UNITED STATES PATENT AND TRADEMARK OFFICE

APPLICATION NO.	FILING DATE	FIRST NAMED INVENTOR	ATTORNEY DOCKET NO.	CONFIRMATION NO.
09/624,798	07/24/2000	Paul C Coffin	10001664-1	6517

Office Action Summary

DETAILED ACTION

Fig. 15, annotated, 1st configuration**Fig. 14, annotated, 2nd configuration**

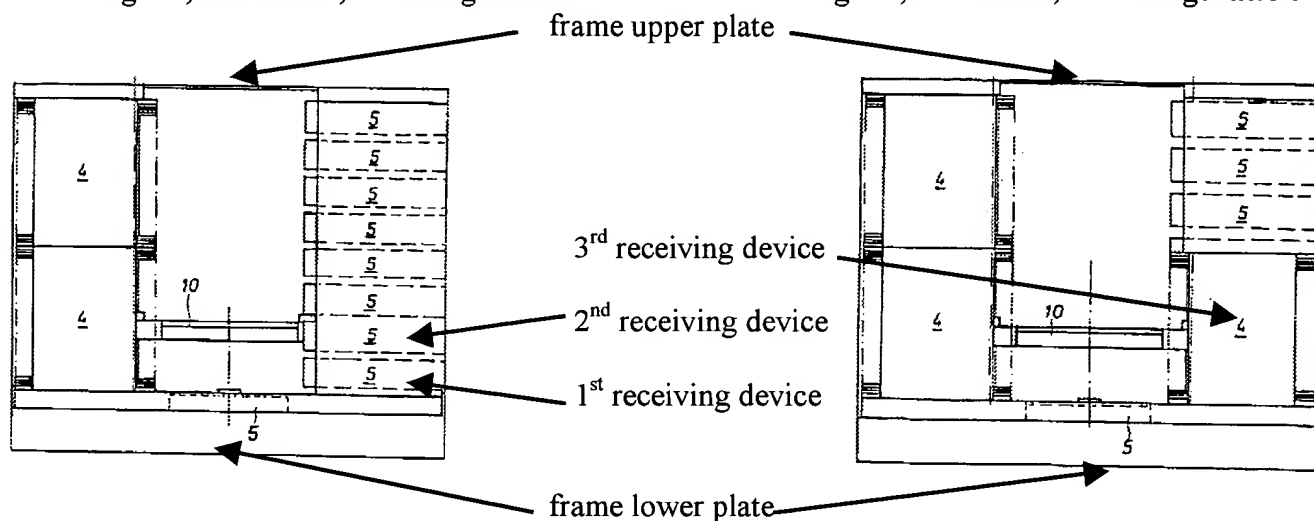
As recited in claims 1, 14 and 20, Menke et al show a reconfigurable cartridge processing module for use in a data storage system, comprising: a frame, said frame having a lower plate and an upper plate positioned in generally parallel, spaced-apart relation, said lower and upper plates of said frame having a plurality of sets of mounting locations provided thereon so that said frame defines a first component configuration (see Fig. 15) and a second component configuration (see Fig. 14), the first component configuration comprising: a first cartridge receiving device 5 mounted to a first set of the plurality of sets of mounting locations provided on said frame so that said first cartridge receiving device is located at a first position within said frame; and a second cartridge receiving device 5 mounted to a second set of the plurality of sets of mounting locations provided on said frame so that said second cartridge receiving device is located at a second position within said frame, said first and second cartridge receiving devices together occupying a volumetric space within said frame, wherein said first and second cartridge receiving devices are located substantially between the upper and lower plates of said frame when said frame is in the first component configuration; the second component configuration comprising a third cartridge receiving device 4 mounted to a third set of the plurality of sets of mounting locations provided on said frame, said third cartridge receiving device occupying substantially the same volumetric space within said frame as is occupied by said first and second cartridge receiving devices in said first component configuration (see annotated Figs. 14-15),

wherein said third cartridge receiving device is located substantially between the upper and lower plates of said frame when said frame is in the second component configuration.

The above is only one example of many possible interpretations of the reference which satisfy the claim language. Alternatively, Fig. 14 may be interpreted as the first configuration with Fig. 13 as the second configuration.

As recited in claims 5 and 15, Menke et al show that the second position is located adjacent the first position so that said second cartridge receiving device is located adjacent said first cartridge receiving device when said frame is in the first component configuration (see positions of 1st receiving device and 2nd receiving device in Fig. 15 annotated above).

Kersey et al Fig. 4b (annotated)

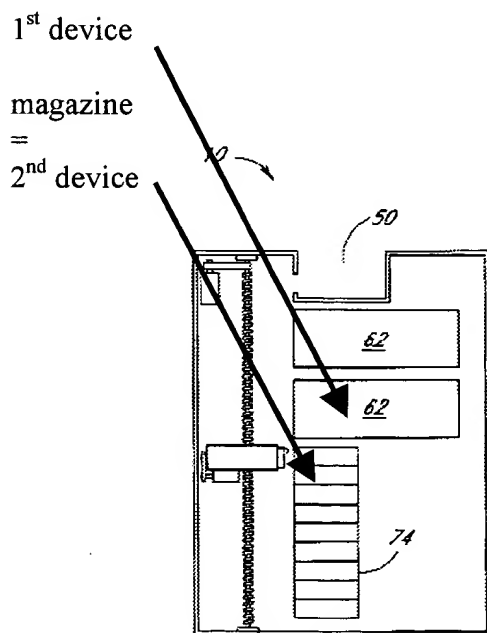
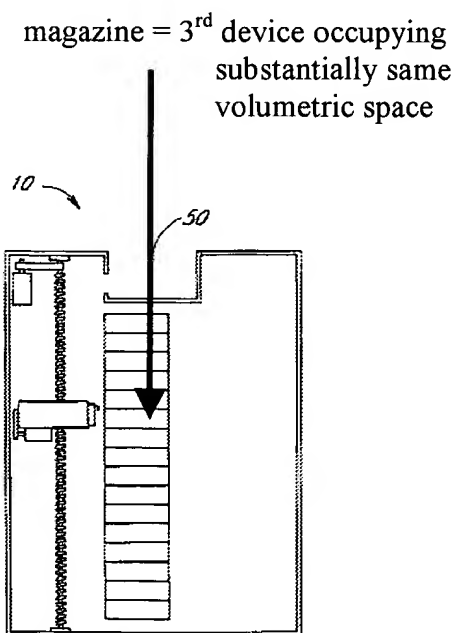
As recited in claims 1, 3, 5-6, 10, 12, 14-18 and 20, insofar as they are understood in view of the indefiniteness rejections, Kersey et al show a reconfigurable cartridge processing module (see teachings in paper no. 5 and arguments below).

On page 10, Applicant argues that "the full-length cartridge rack 50 of Figure 4c, fails to meet the requirements of claim 1 in that the full-length cartridge rack 50 does not "occupy substantially the same volumetric space within said frame as is occupied by" the tape drive 62 and cartridge rack 74 of Figure 4b. Instead, the full-length cartridge rack 50 also occupies the space previously occupied by the upper tape drive 62. Stated another way, in Kersey, the third cartridge receiving device (e.g., Kersey's full-length cartridge rack 50) in the second configuration (Kersey's Figure 4c) occupies a space greater than that occupied by the first and second cartridge receiving devices (e.g., Kersey's lower tape drive 62 and rack 74) in the first configuration (Kersey's Figure 4b)." The Examiner has considered this argument thoroughly and

agrees that, in Kersey, the third cartridge receiving device (e.g., Kersey's full-length cartridge rack 50) in the second configuration (Kersey's Figure 4c) occupies a space greater than that occupied by the first and second cartridge receiving devices (e.g., Kersey's lower tape drive 62 and rack 74) in the first configuration (Kersey's Figure 4b).

The Examiner notes, however, that the independent claims require that said volumetric space be occupied by said third cartridge receiving device. This limitation has been met. Nothing in the claims precludes the third cartridge receiving device from occupying additional space.

Kersey et al Fig. 4b (annotated)**= first configuration****Kersey et al Fig. 4a (annotated)****= second configuration**

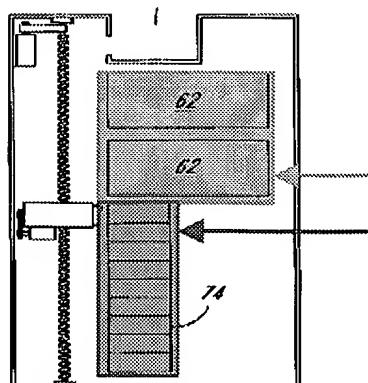
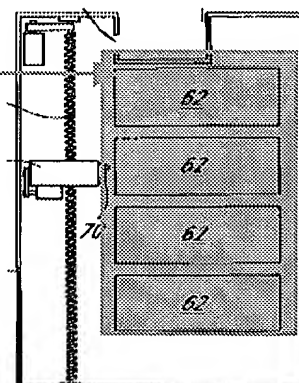
See arguments below regarding independent claims 1, 10, 14 and 20.

As recited in claims 2 and 11, Kersey et al show that said first cartridge receiving device (drives 62 and 62 taken together) comprises a half-width cartridge read/write device (said device is half-width insofar as it occupies substantially half the width of the frame; see Fig. 5).

As recited in claims 4 and 13, Kersey et al show that said third cartridge receiving device (drives 62 and 62 and 62 and 62 taken together) comprises a full-width cartridge read/write device (said device is full-width insofar as it occupies substantially the full width of the frame).

As recited in claim 19, Kersey et al show that said third cartridge receiving means (drives 62 and 62 and 62 and 62 taken together) comprises cartridge read/write means 62 for reading data from and writing data to said at least one data cartridge.

Moreover, nothing in the claims precludes the interpretation applied above for claims 1-2, 4, 10-11, 13-14 and 19-20, wherein the 1st and 3rd cartridge receiving devices each comprise more than one drive 62. Clearly, the limitation "occupying substantially the same volumetric space within the frame" is met.
